## TOWN OF YORKTOWN PLANNING BOARD

### PUBLIC MEETING AGENDA YORKTOWN TOWN HALL BOARD ROOM 363 Underhill Avenue, Yorktown Heights, NY 10598

March 28, 2022  
7:00 PM

3. **Kitchawan Solar**  
**Decision Statement Site Plan & Special Permit**  
*Location:* 70.06-1-2 & 3; 716 Kitchawan Road  
*Contact:* Ecology Kitchawan Community Solar Farm, LLC  
*Description:* Proposed 2 MW ground mounted large-scale solar energy system.

<p>Drawing Title</p> <p>PLANTING PLAN SITE SOUTHERN PORTION</p>
---

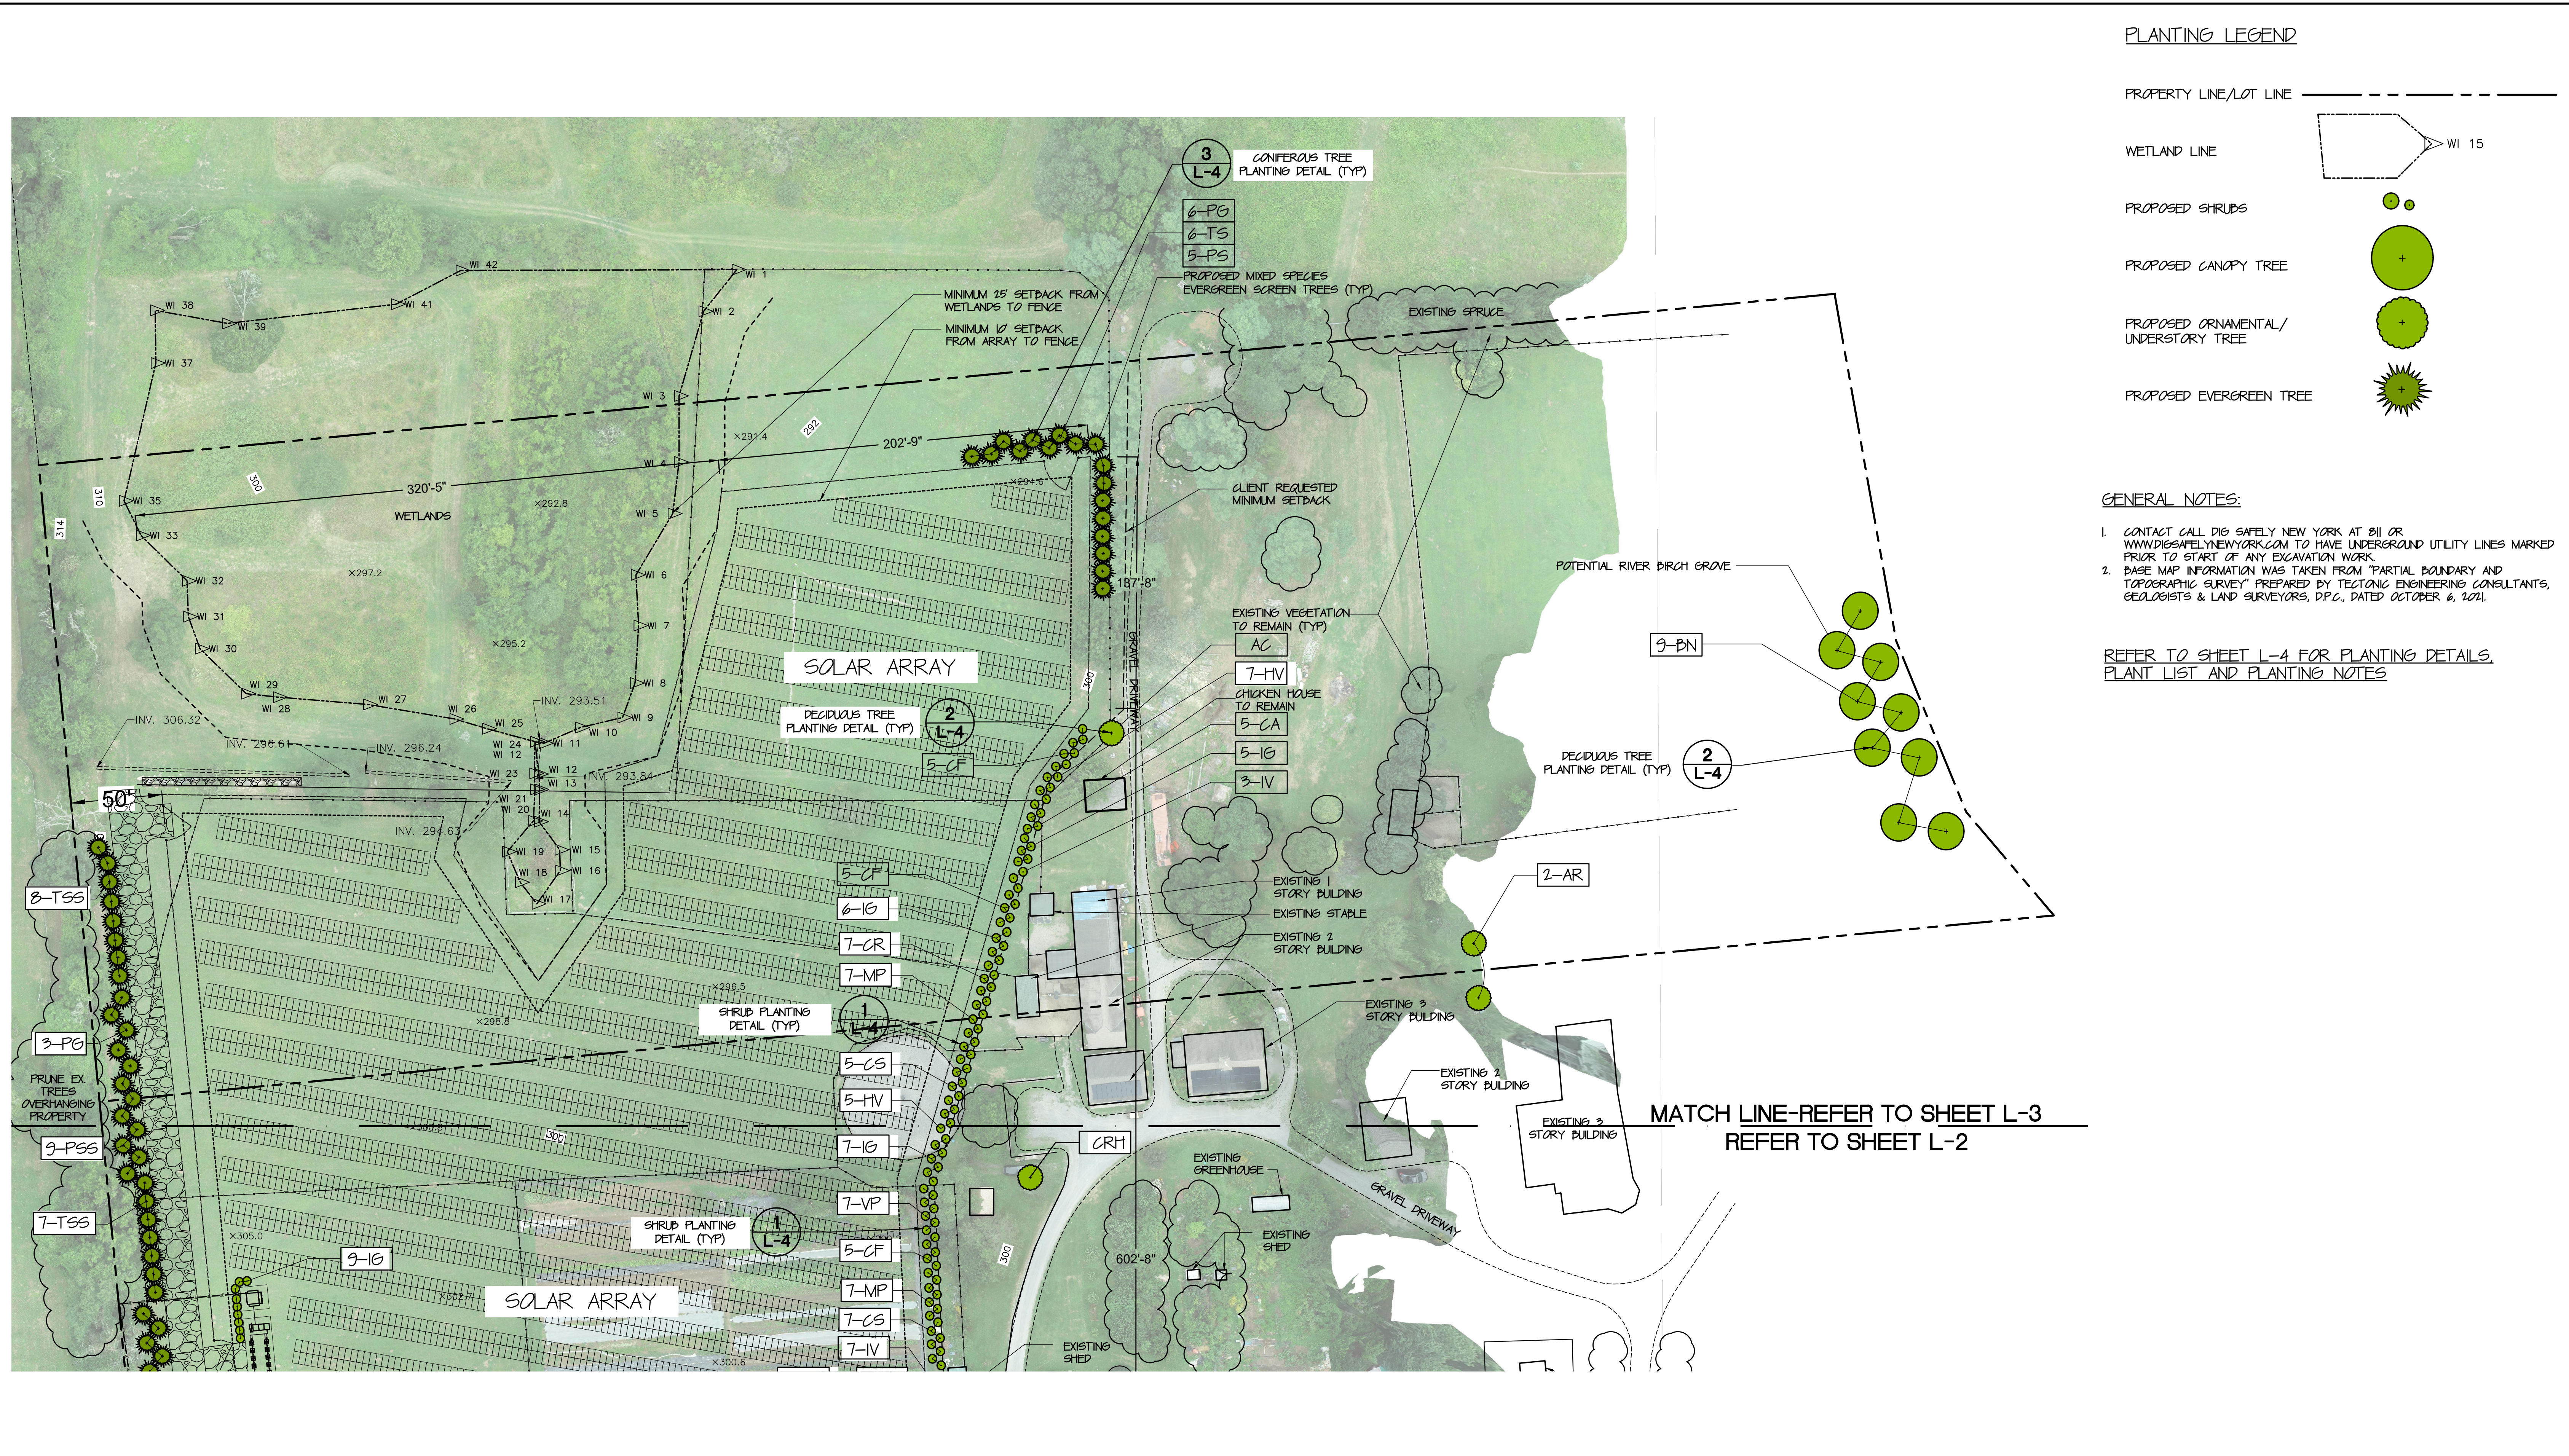
3. Ecogy has not addressed the TCAC's point 7 which states "The proposed increased diversity of the row of screening trees is, in the TCAC's view, insufficient. The original number of 85 Green Giant Arborvitae has been reduced to 77 trees. Adding 2 more White Pines and 6 White Spruces does not reduce the planting of a monoculture of Green Giant Arborvitae. Ecogy should do more to reduce such a monoculture." This issue needs to be addressed.

7. Ecology has increased the diversity of the row of screening trees as requested. Please see the new landscaping plans included with this memo.
